**SAFETY
RECALL**

SR16-18A

DATE :	APRIL 2016	SECTION :	05 - Cooling
SUBJECT:	TRANSMISSION OIL COOLER – AIR PURGE LINE REMOVAL

FIGURE 4 : SURGE TANK

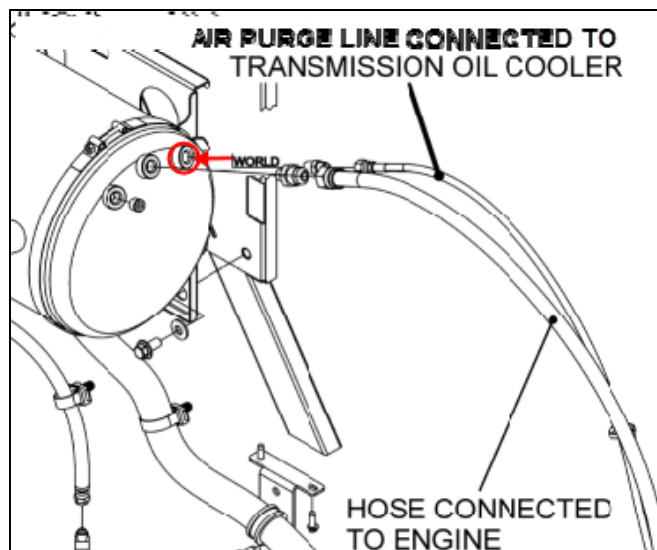
3. On system drained, disconnect the air purge line at the surge tank (see FIGURE 4). Put Loctite 567 thread sealant on ¼ hex socket plug (#501800) and then screw the plug to the surge tank.

PLUG TIGHTENING: finger tighten then tighten 2 additional turns

FIGURE 5: AIR PURGE LINE

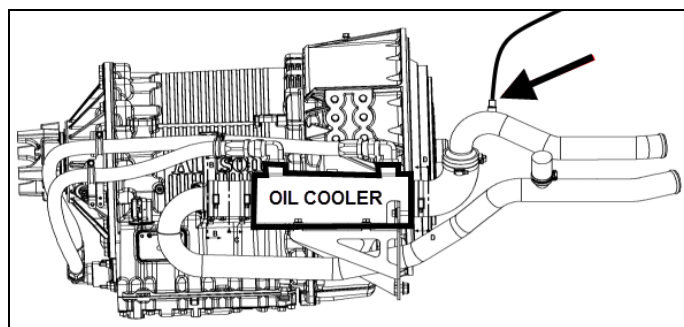
4. Disconnect the transmission oil cooler air purge line at the coolant pipe near the oil cooler (see FIGURE 5). Discard the air purge line. Put Loctite 567 thread sealant on ¼ hex socket plug (#501800) and then screw the plug to the coolant pipe fitting.

PLUG TIGHTENING: finger tighten then tighten 2 additional turns

FIGURE 6: HARD FUEL LINE BRAIDED SECTION

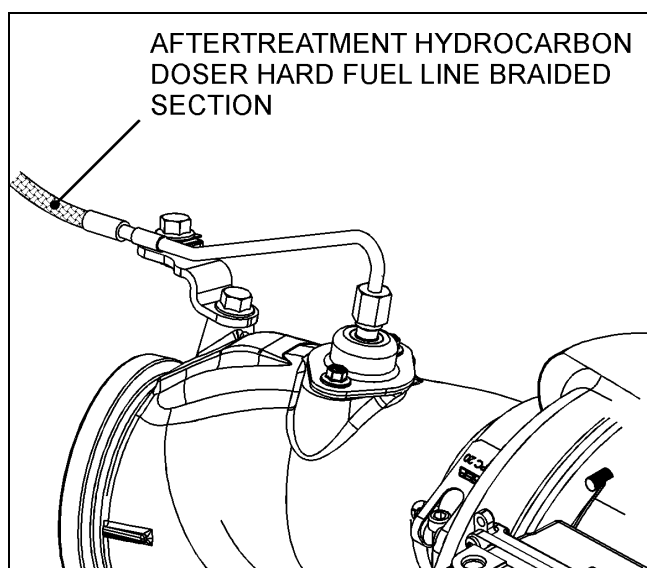
It was determined that rubbing between the air purge line (removed in Part 1) and the aftertreatment hydrocarbon doser hard fuel line may seriously damage the hard fuel line.

1. Locate the braided section of the aftertreatment hydrocarbon doser hard fuel line (FIGURE 6)

The aftertreatment hydrocarbon doser hard fuel line must be inspected in order to make sure it is not damaged. It must be replaced if damage is found.
